GULF STATES UTILITIES COMPANY

River Bend Station-Unit 1
Docket No. 50-458

Enclosed is the Gulf States Utilities Company (GSU) response to Safety Evaluation Report (SER) Confirmatory Item #19 - Hydrogen Control (SER Section 6.2.5, Page 6-32/33.) Attachment 1 contains the GSU endorsements for various Hydrogen Control Owners Group (HCOG) submittals. These letters should be utilized to provide background and reference material for SER Confirmatory Item #19. Attachment 2 contains a revision to the Request for Additional Information (RAI) on the Hydrogen Ignition System (HIS) transmitted to W. J. Cahill (GSU) by A. Schwencer (Nuclear Regulatory Commission - NRC) on December 2, 1983 and supercedes the original GSU response from J. E. Booker (GSU) to H. R. Denton (NRC) dated December 30, 1983 (GSU Letter No. RBG-16679).

REQUEST FOR ADDITIONAL INFORMATION FOR USE IN THE EVALUATION OF
THE HYDROGEN IGNITION SYSTEM FOR THE RIVER BEND STATION, UNIT 1
MARK III CONTAINMENT

PLAN EL 130-7"
 REACTOR BLDG CONTAINMENT

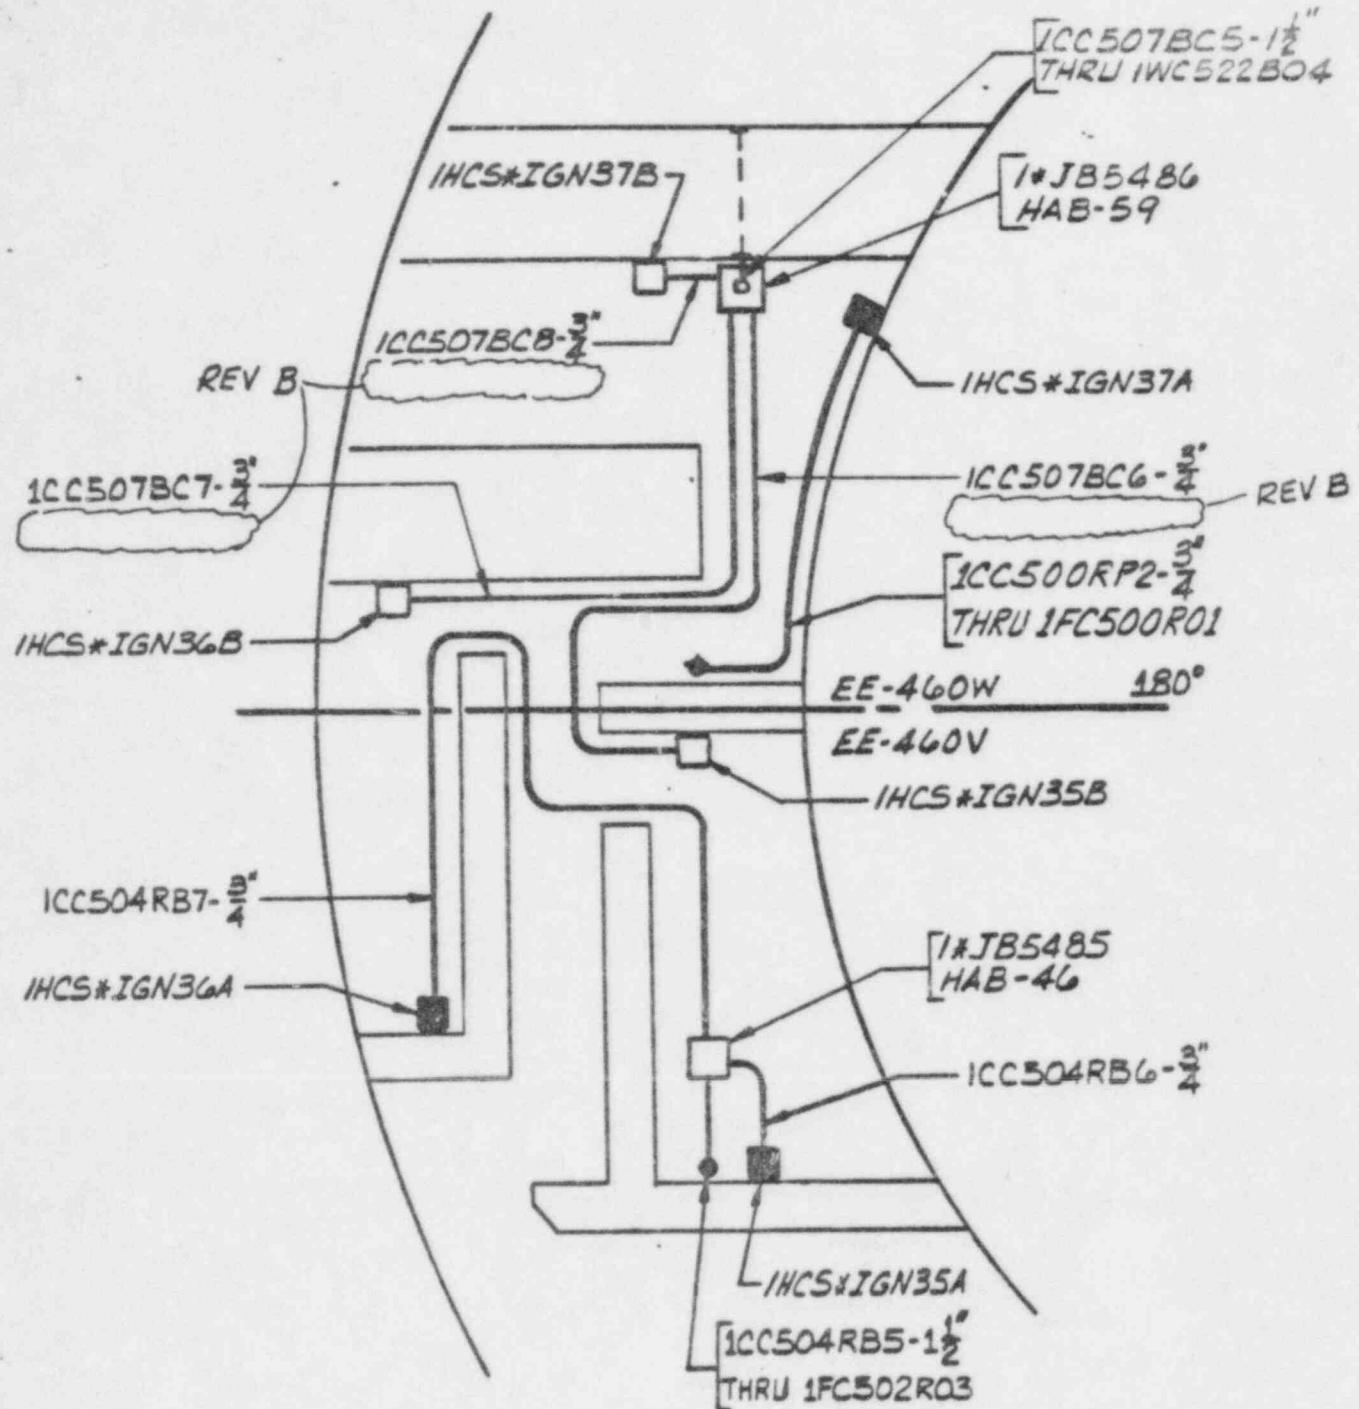
16 DWGS EE-46OU, V, W, X, AC, AD, AE, AF, AJ, AK & AX ARE REVISED ADDING CONDUITS, JUNCTION BOXES, AND LOCATING HYDROGEN IGNITERS AS SHOWN ON PAGES 3 THRU 14.

E&DCR P-21.764A
 PAGE 2 OF 7

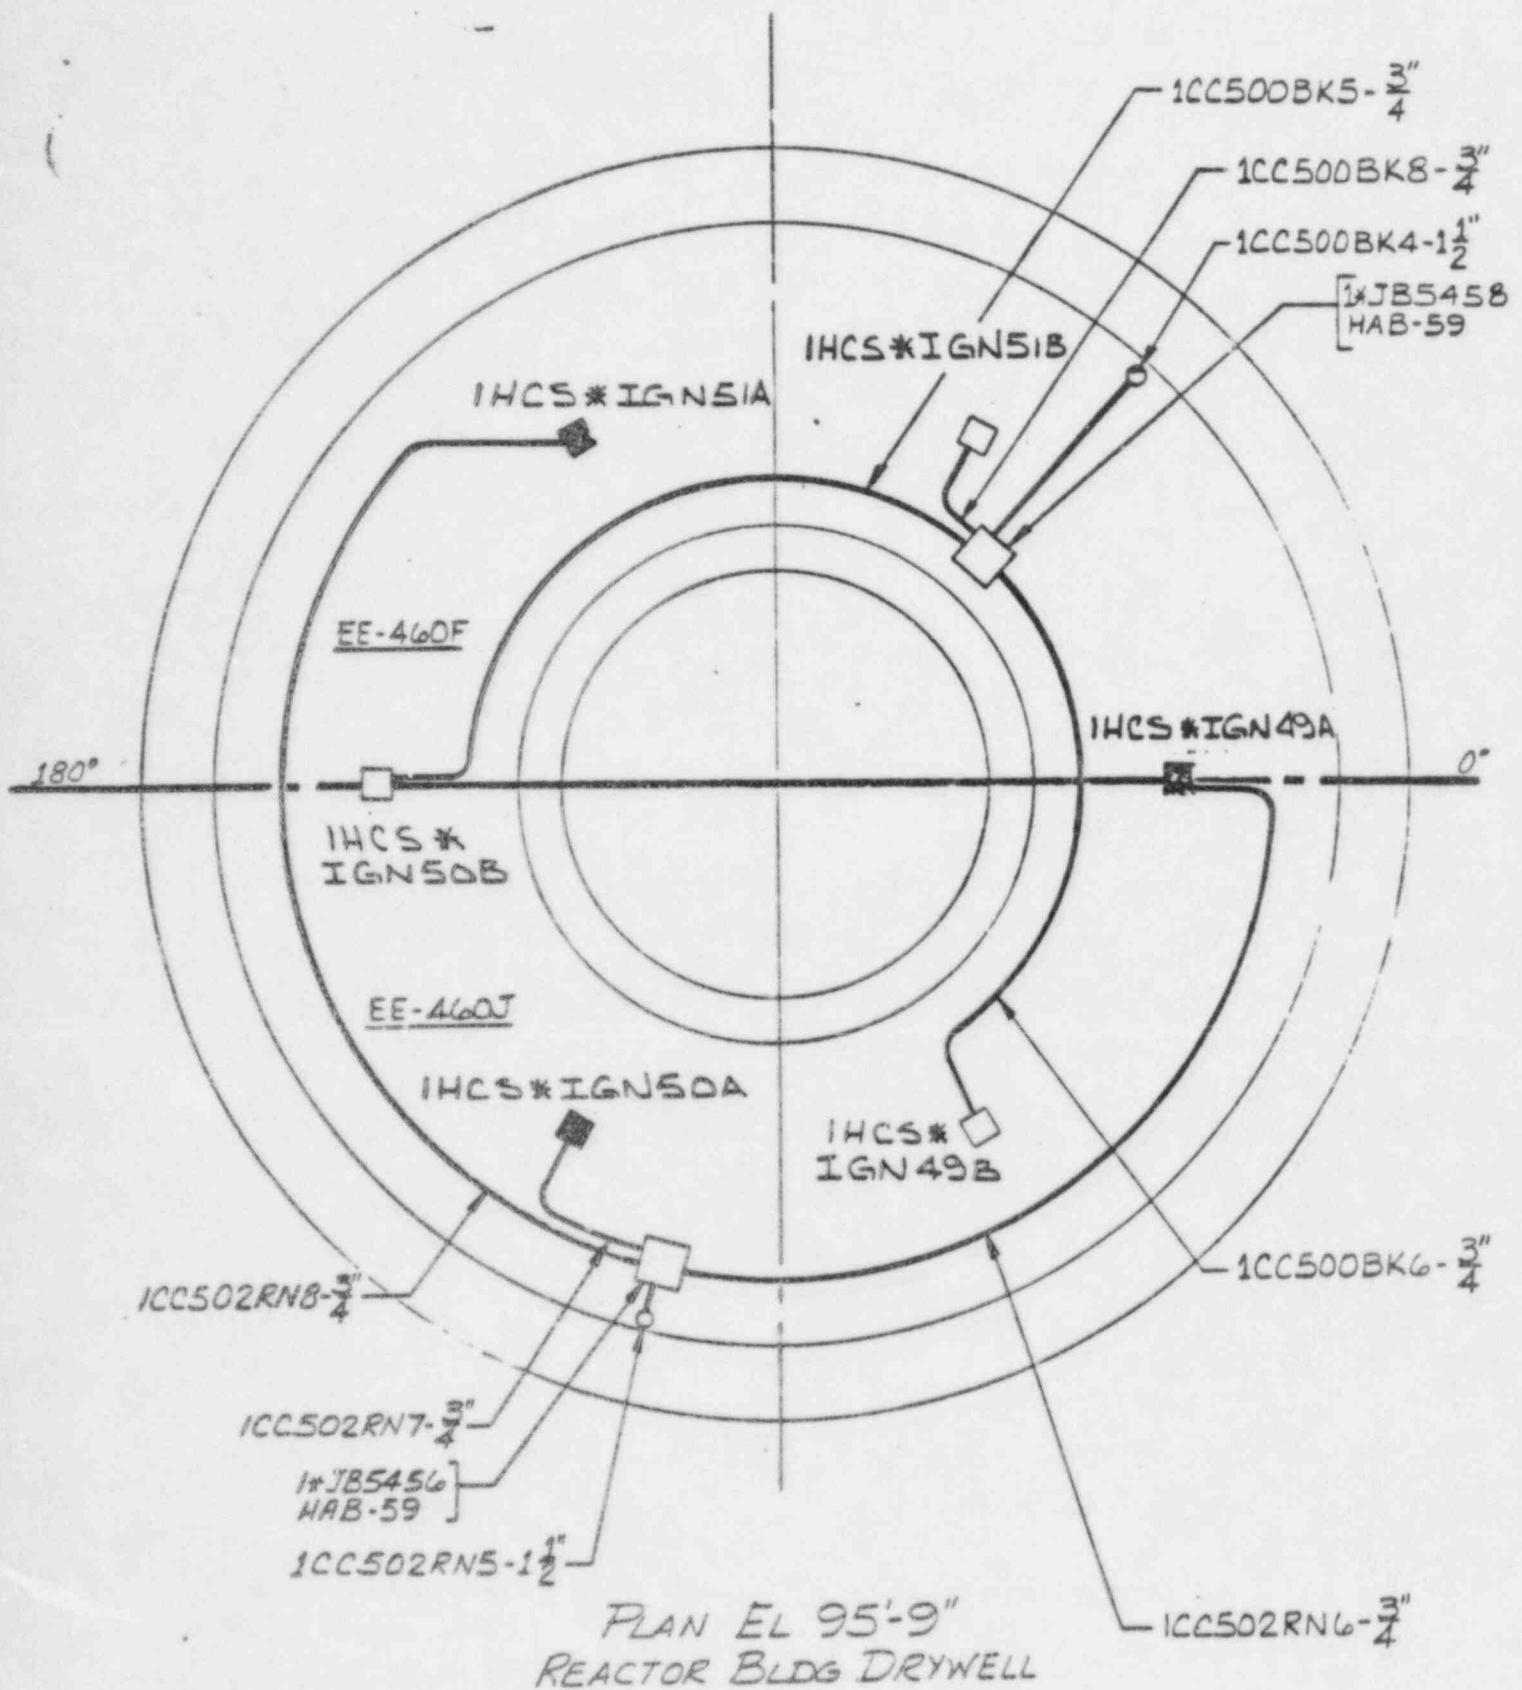
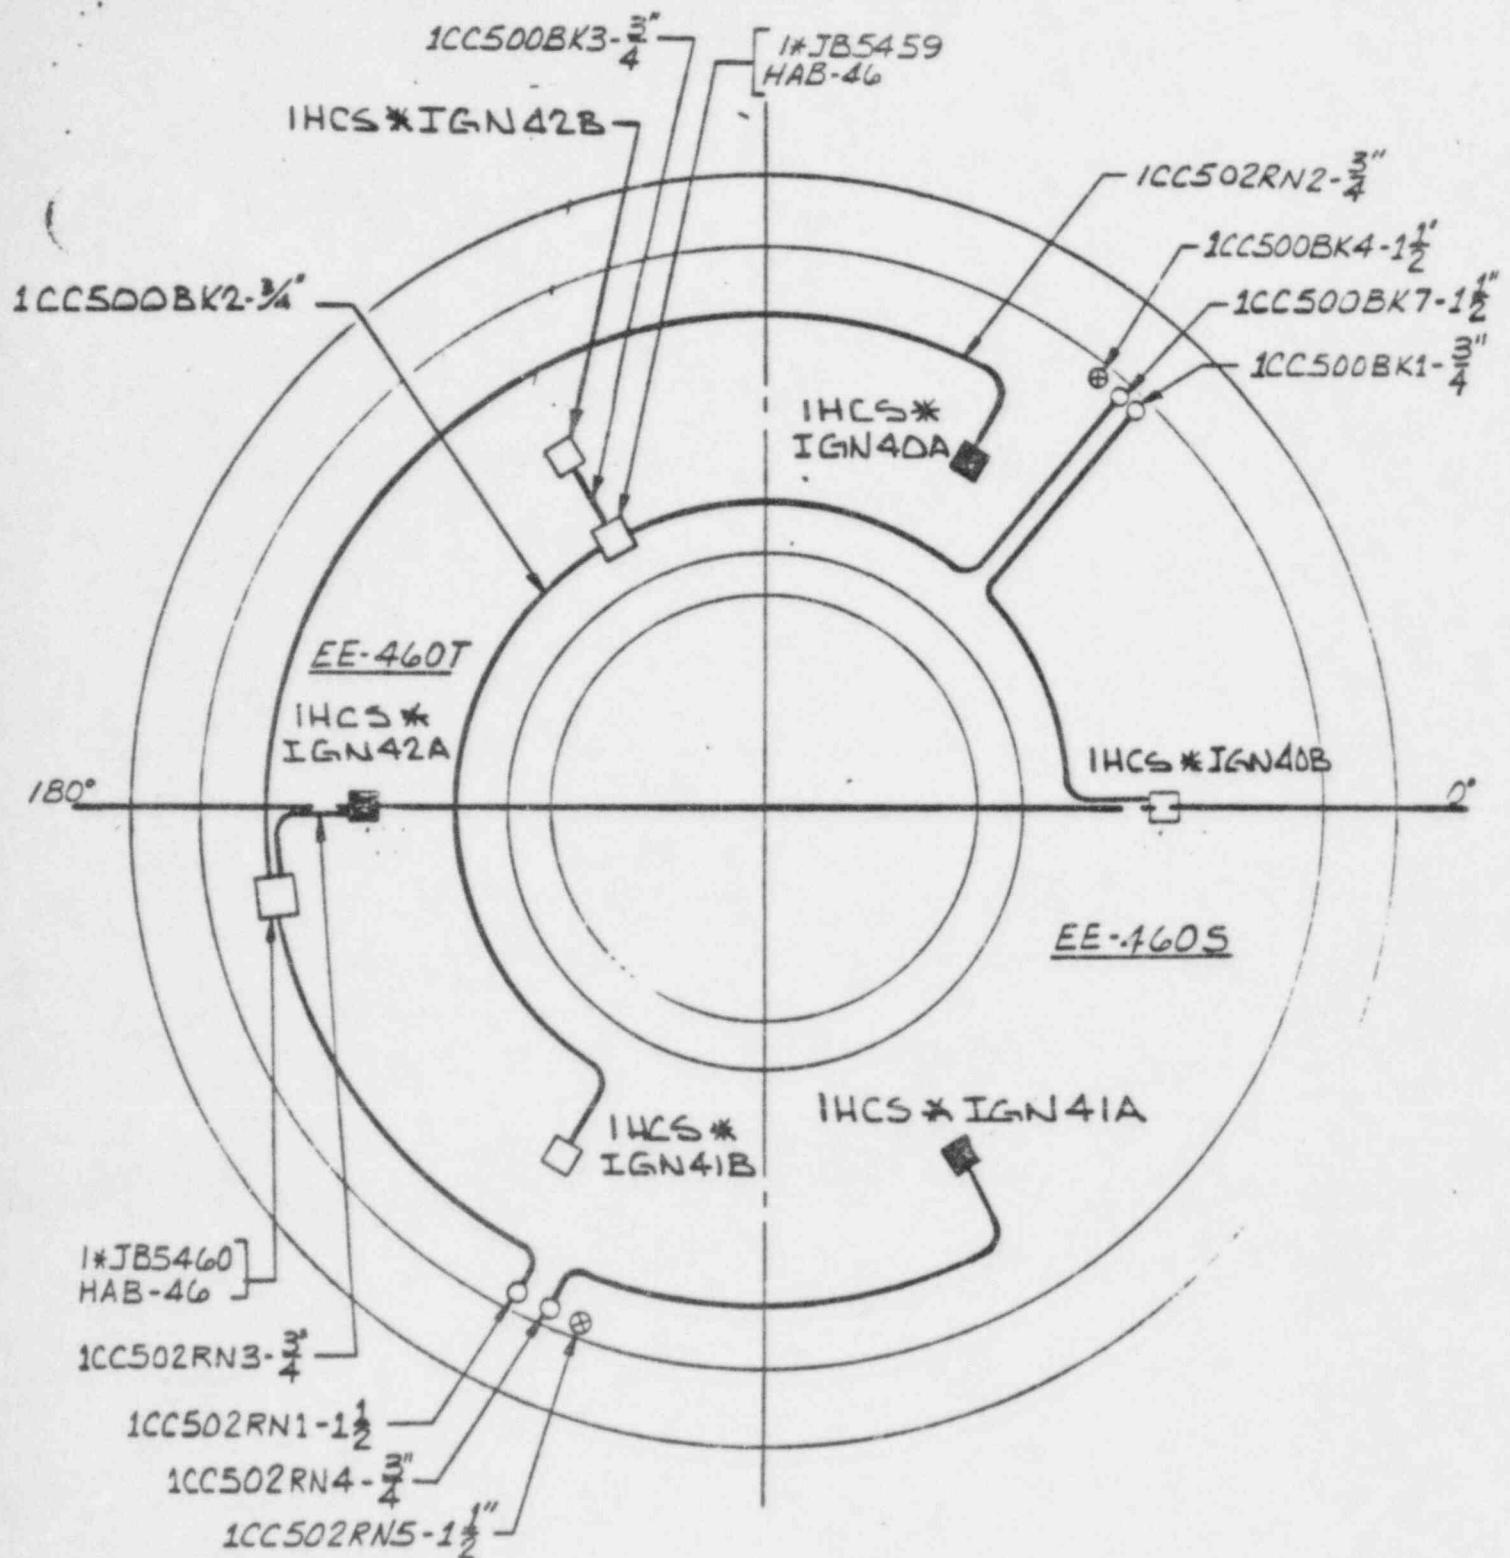
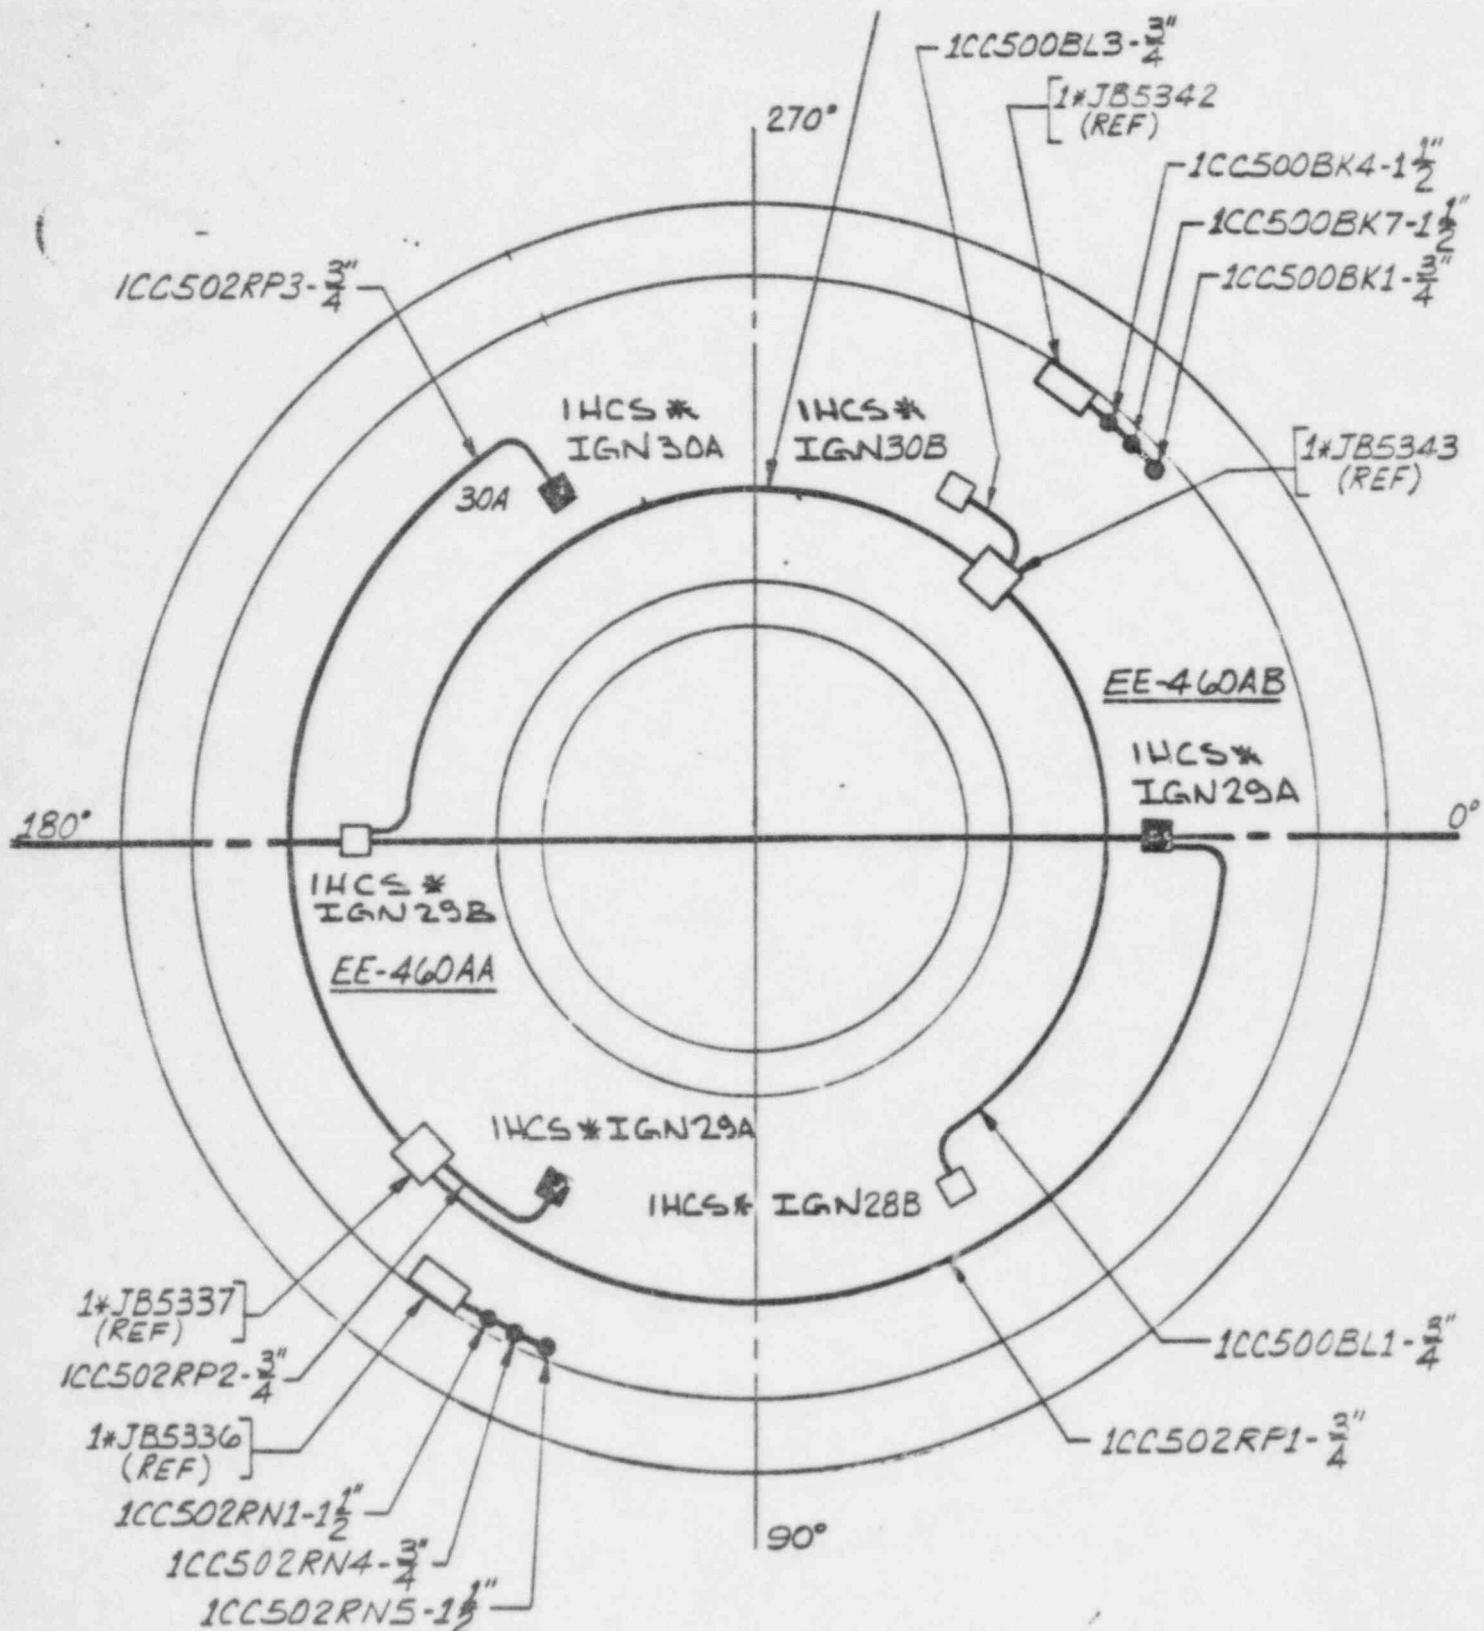
14. DWGS EE-460F, J, S, T, AA & AB ARE REVISED ADDING CONDUITS & JUNCTION BOXES & LOCATIONS OF IGNITERS AS SHOWN ON PAGES 2 THRU 7.

REF: EB -15E-7
COOR. J-5

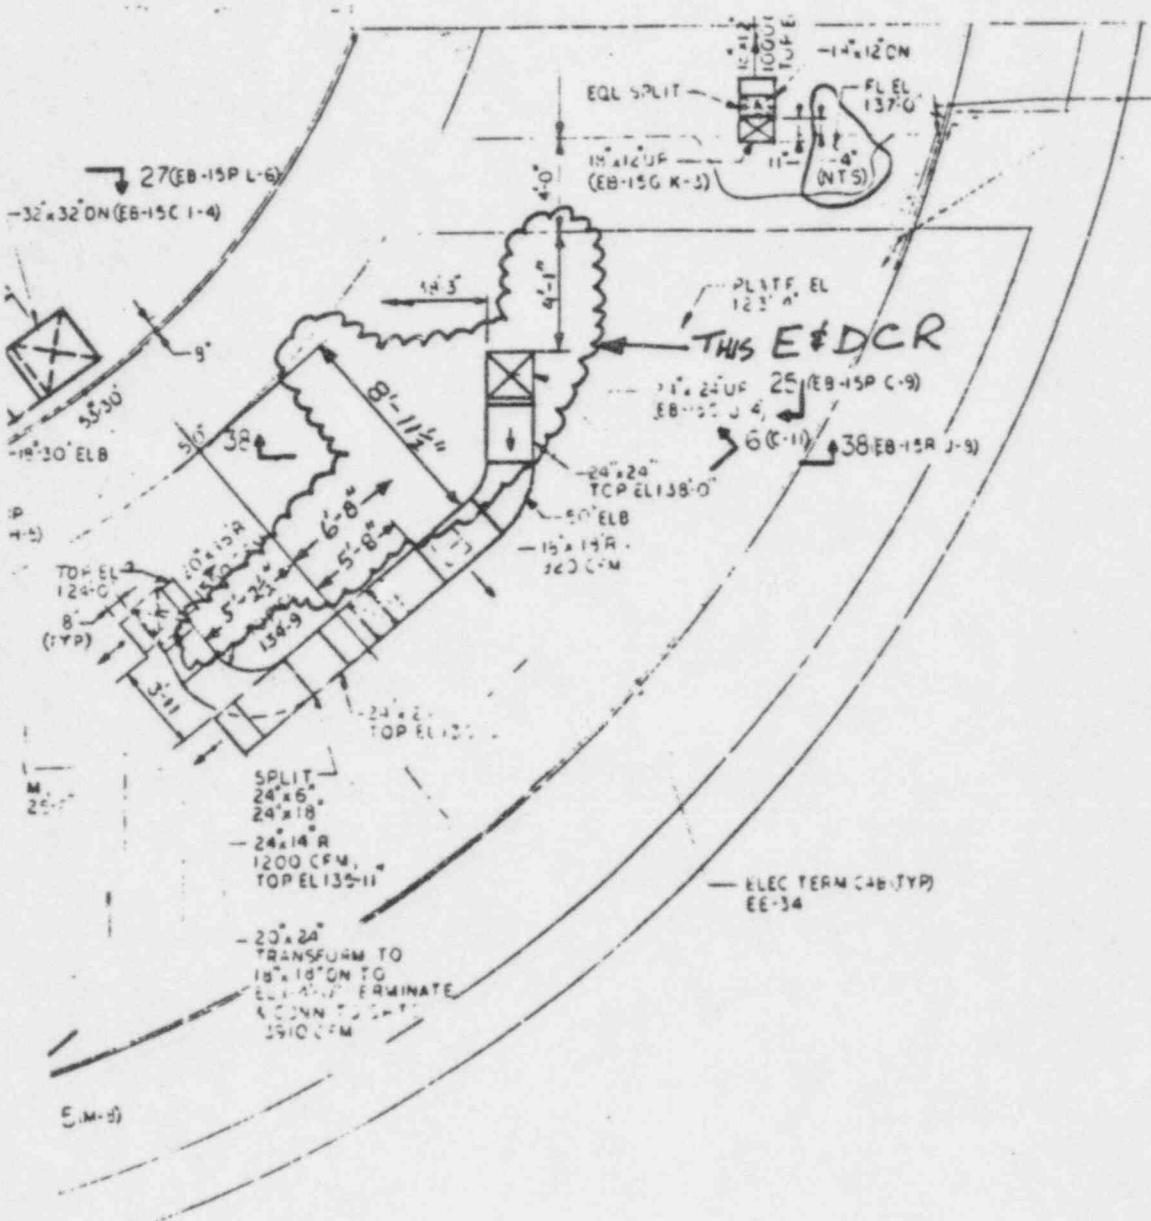
- ① A DUCT RISER LOCATED ON AZIMUTH 241°, EL. 175' OF THE REACTOR BLDG. NEEDS TO BE RELOCATED TO 2'-2" FROM THE CONTAINMENT WALL TO BE IN ALIGNMENT WITH THE FLOOR PENETRATION AT EL. 186'.
- ② TWO 12"X18" SUPPLY AIR REGISTERS LOCATED IN THE MAIN STEAM TUNNEL, APPROX. 20° IN THE REACTOR BLDG., NEEDS TO BE RELOCATED TO SHOW REVISED DIMENSIONS DUE TO THE CONFIGURATION OF THE VENDOR SUPPLIED DUCTWORK.
- ③ THE 24"X24" DUCT SYSTEM AT APPROX. EL. 130', AZIMUTH 50° NEEDS TO BE MODIFIED DUE TO THE PHYSICAL CONFIGURATION OF THE DUCTWORK.

E #DCR PAGE #	EB Dwg. #	CHANGE
2	EB-15P	REGISTER EL. CHANGES AS PER PROBLEM NO 2.
3	EB-15M	DUCT RISER LOCATION CHANGE AS PER PROBLEM NO 1.
4	EB-15K	DUCT RISER LOCATION CHANGE AS PER PROBLEM NO 1.
5 #6	EB-15E	DUCT LINE LOCATION REVISION AS PER PROBLEM NO 3.
